TOWN OF BAY HARBOR ISLANDS PLANNING AND ZONING BOARD

April 17, 2018

Subject: Site Development Plan Application – Revision #1
Atlantis of Bay Harbor – 28 DU Multi-Family Residential Complex
10281 West Bay Harbor Drive
Bay Harbor Islands Acct. No. MB2017-21
MMPA Acct. No. 01-0702-1049

Below are all of the changes since the PZ Board approved the plans on March 21st, 2017:

DRAWING TITLE:
BACK
ELEVATION
SCALE: 3/32"=1'-0" DATE: APRIL 3, 2018
SHEET NUMBER:
A-2.03
P&Z REVISIONS

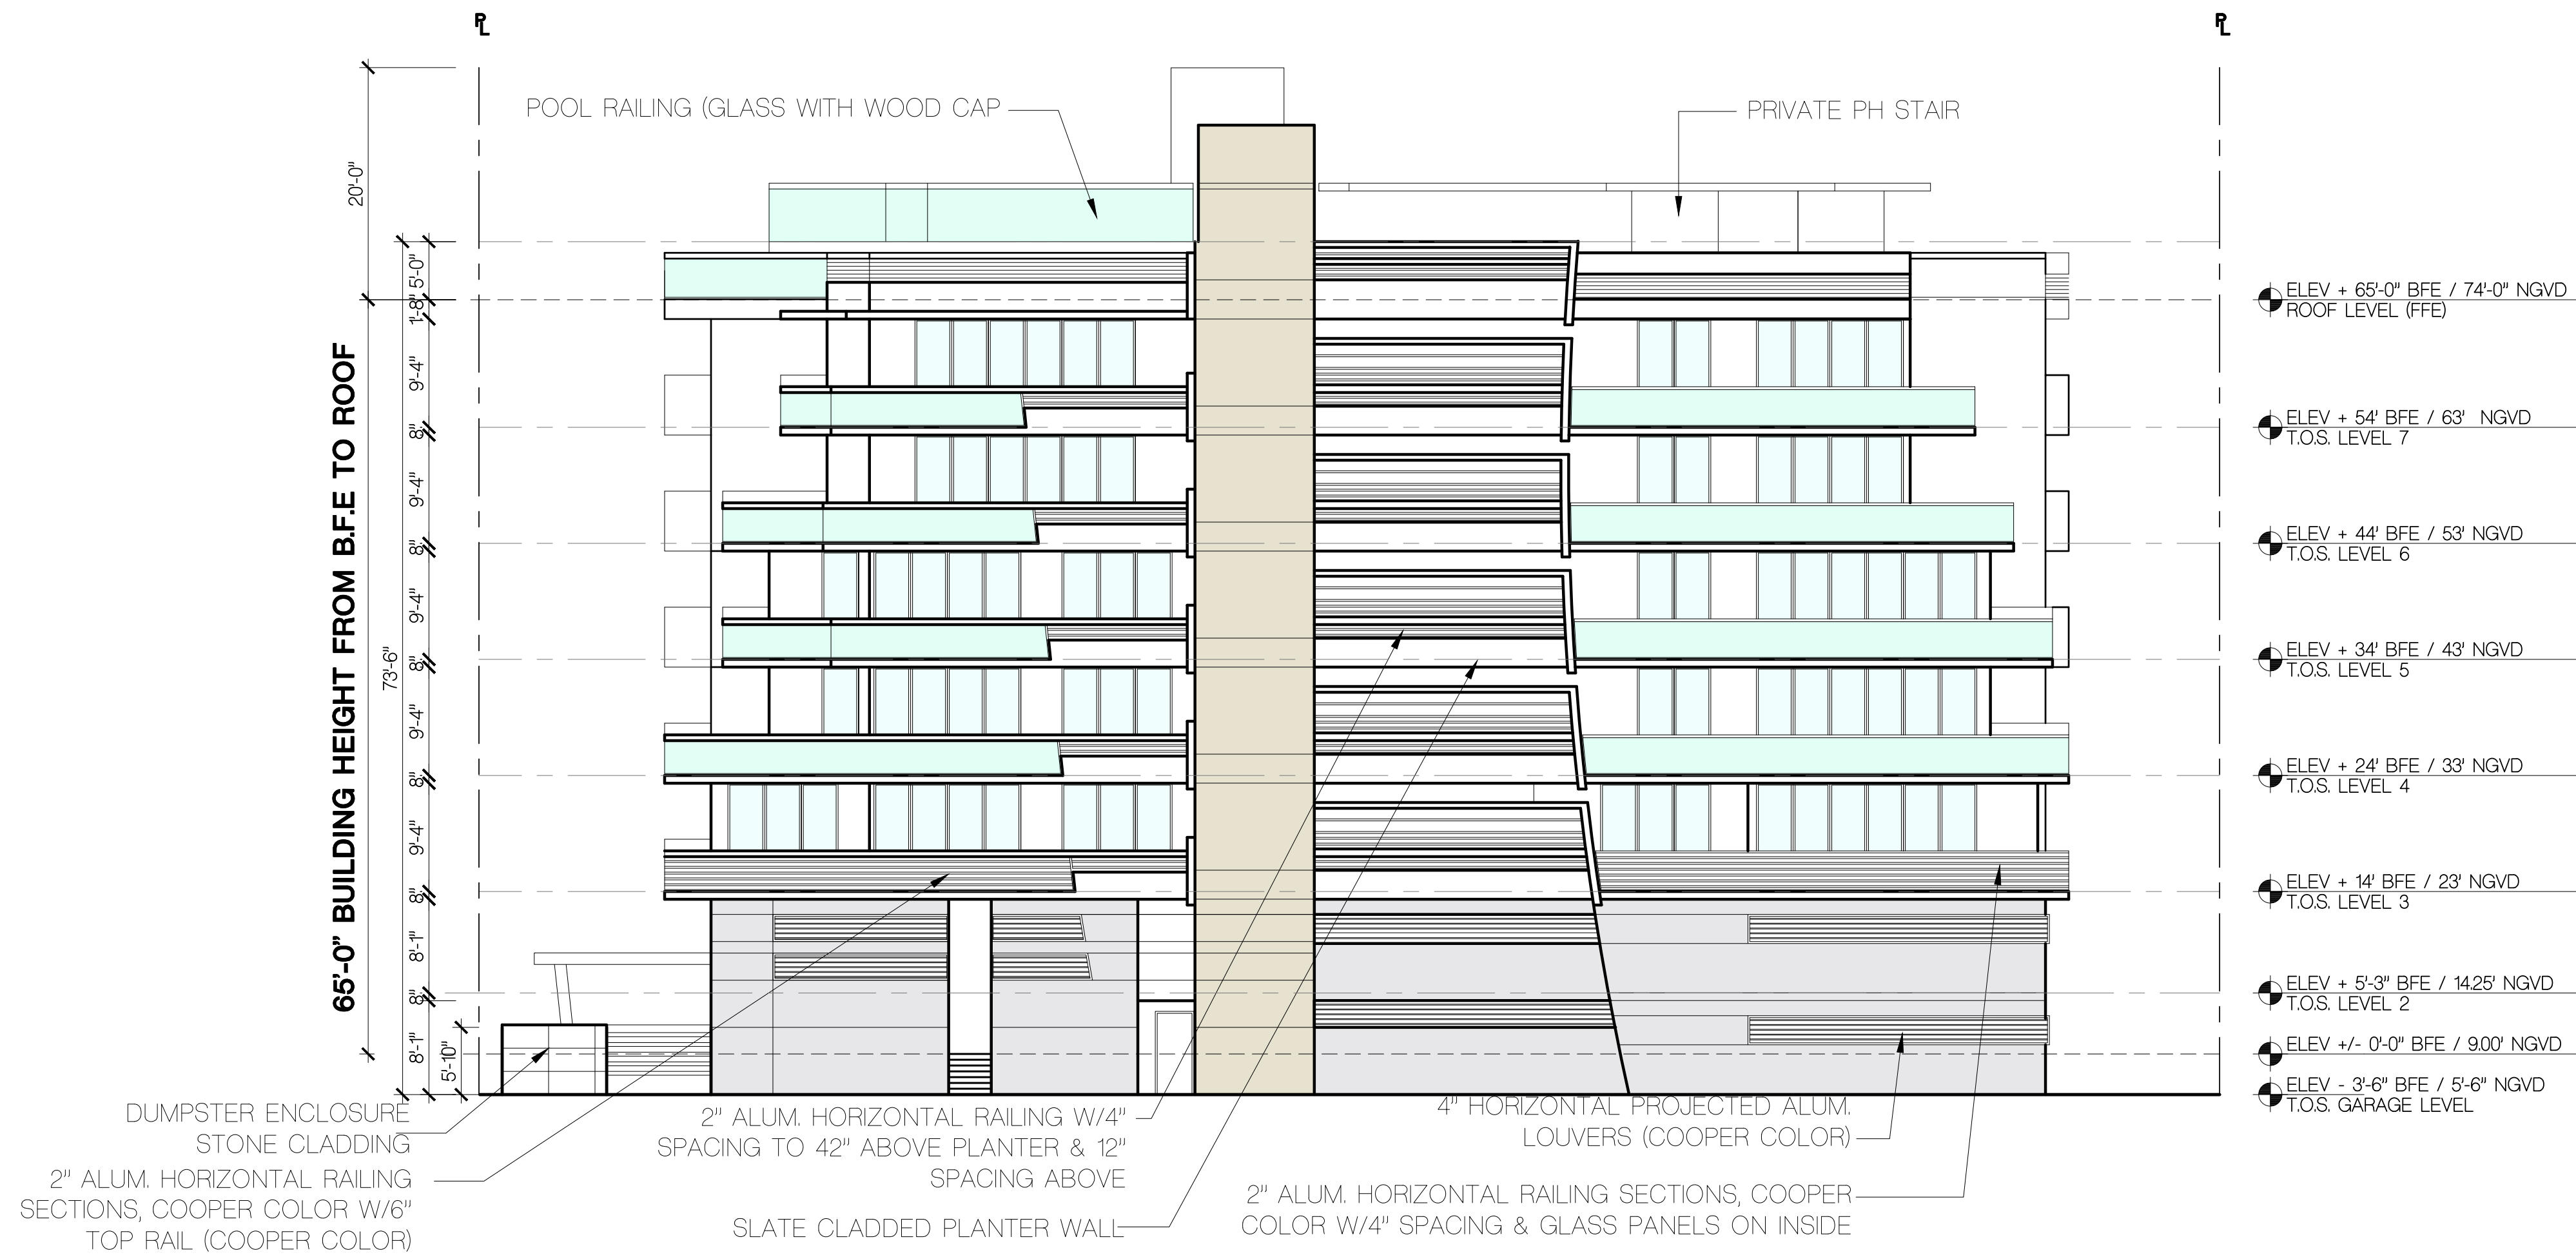
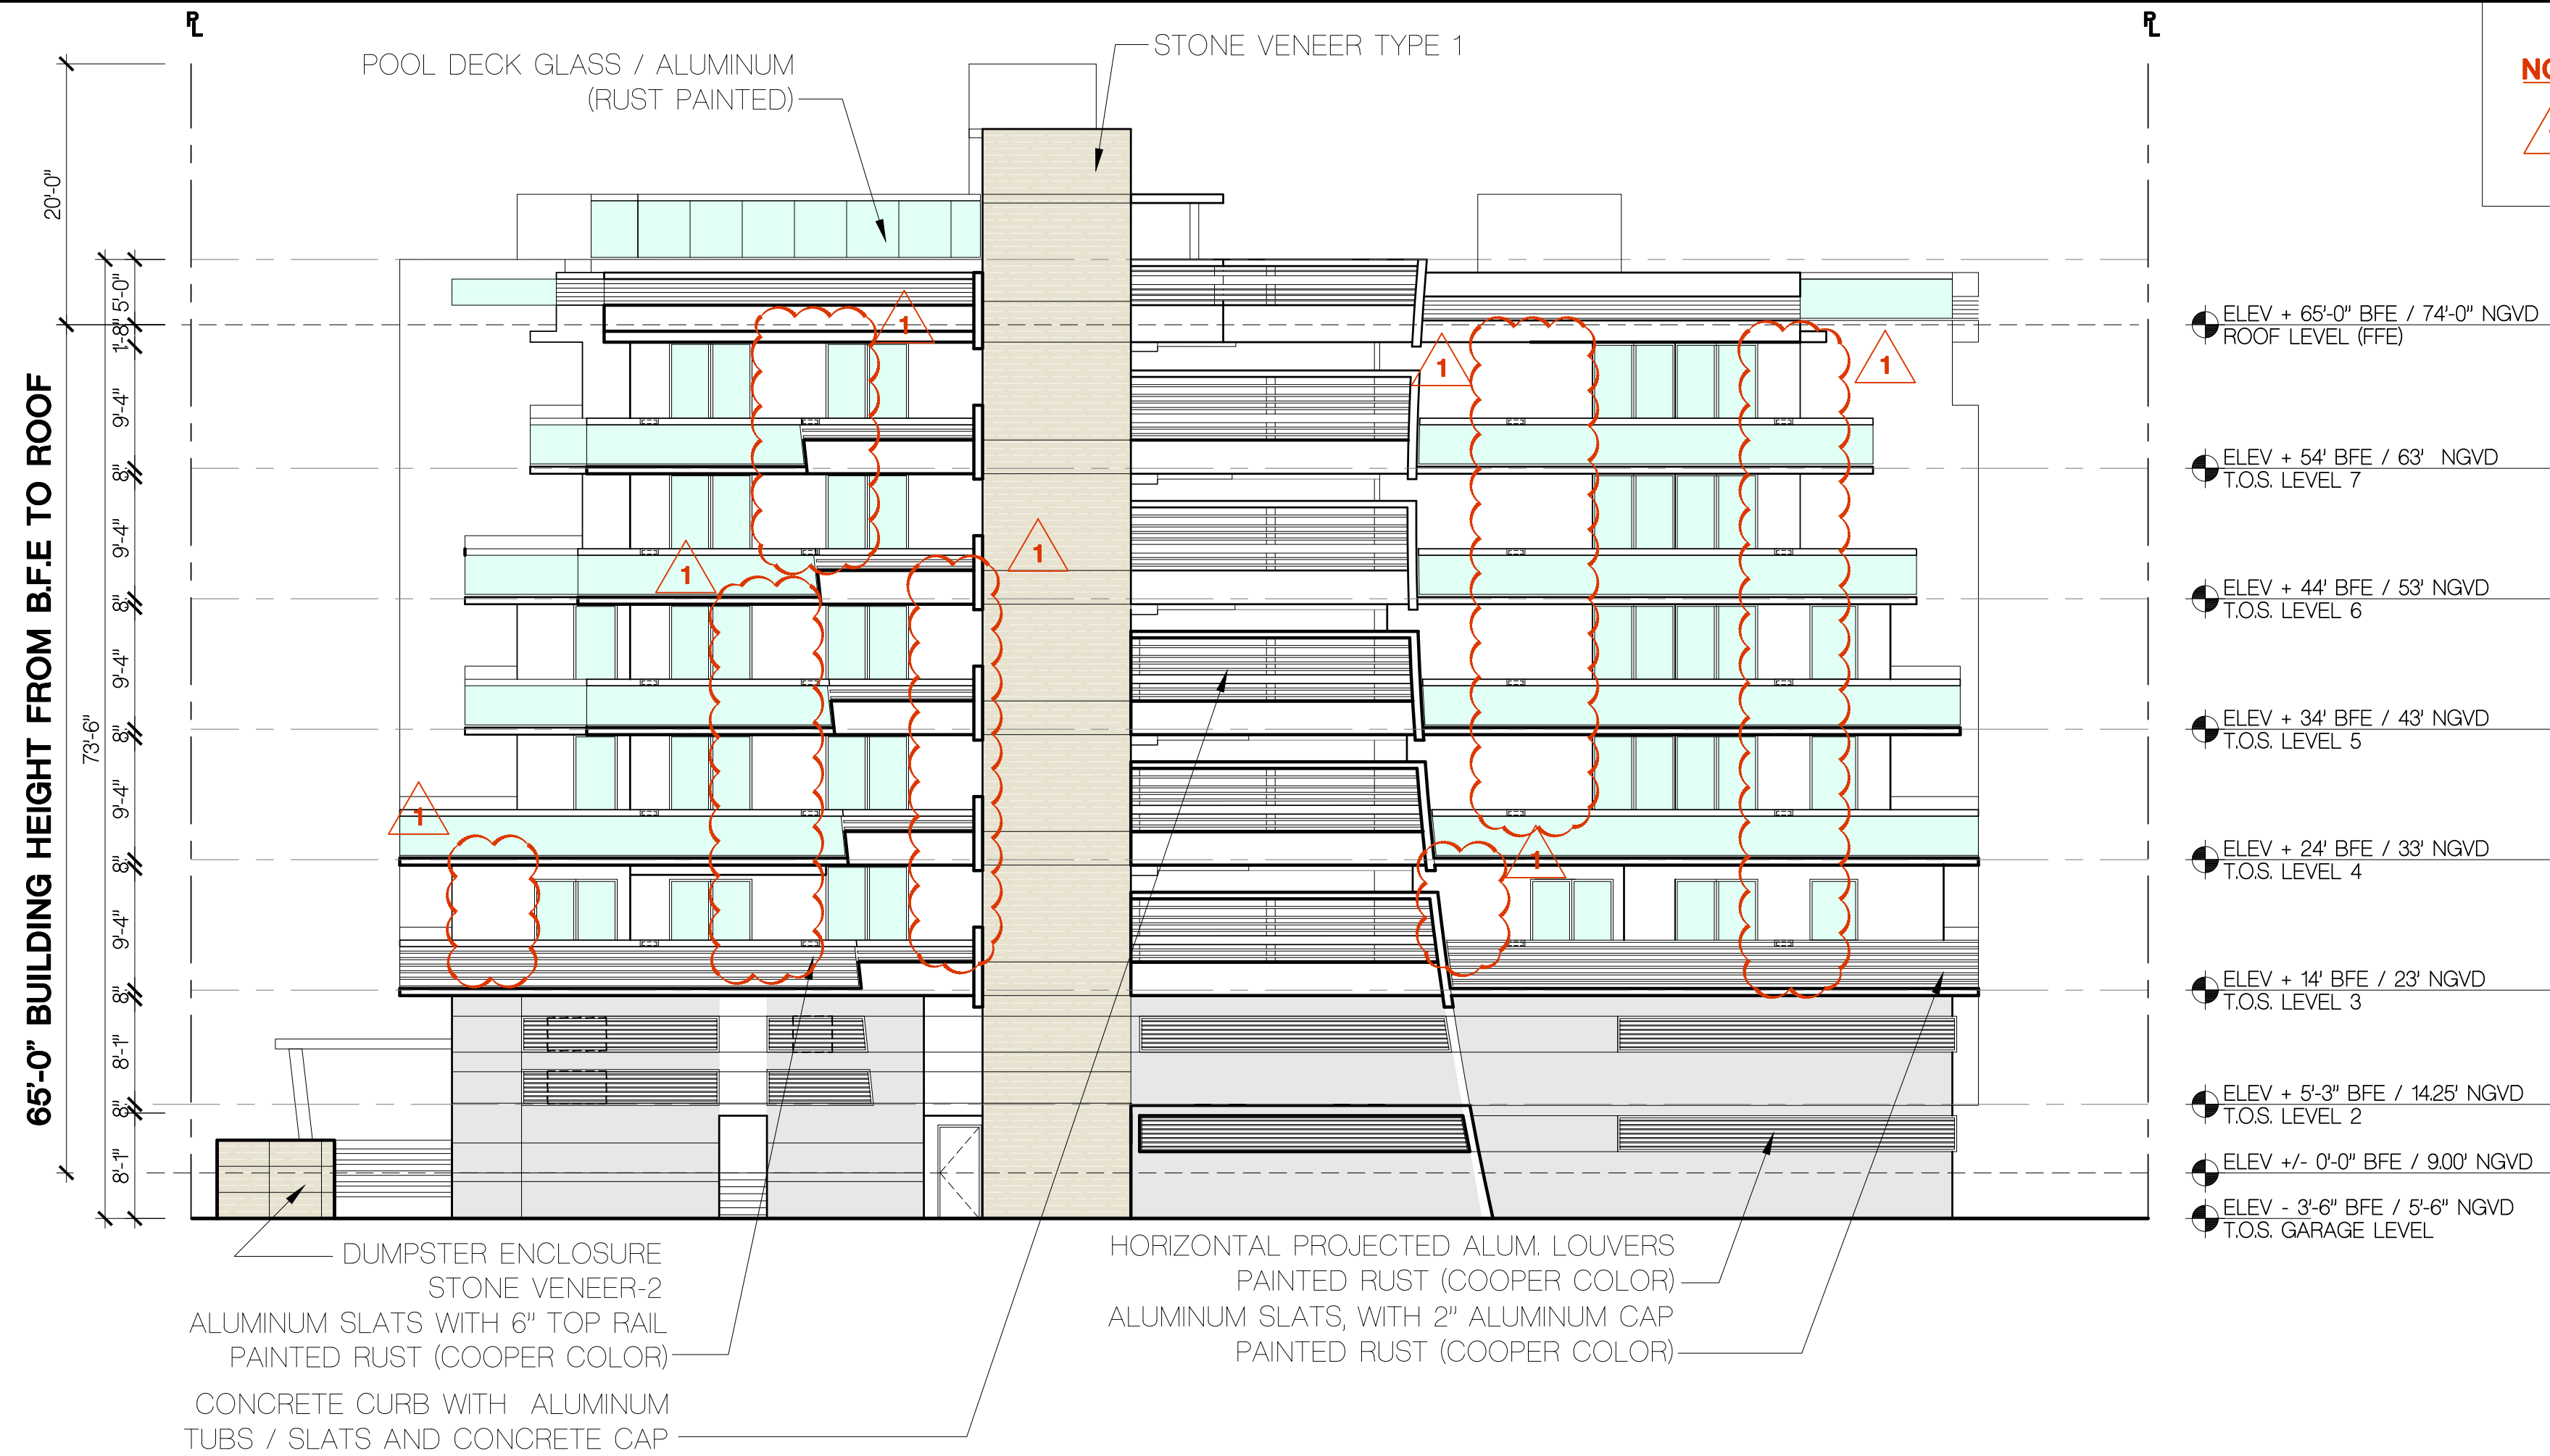
NOTES:
1 REDUCE GLAZING AREA.
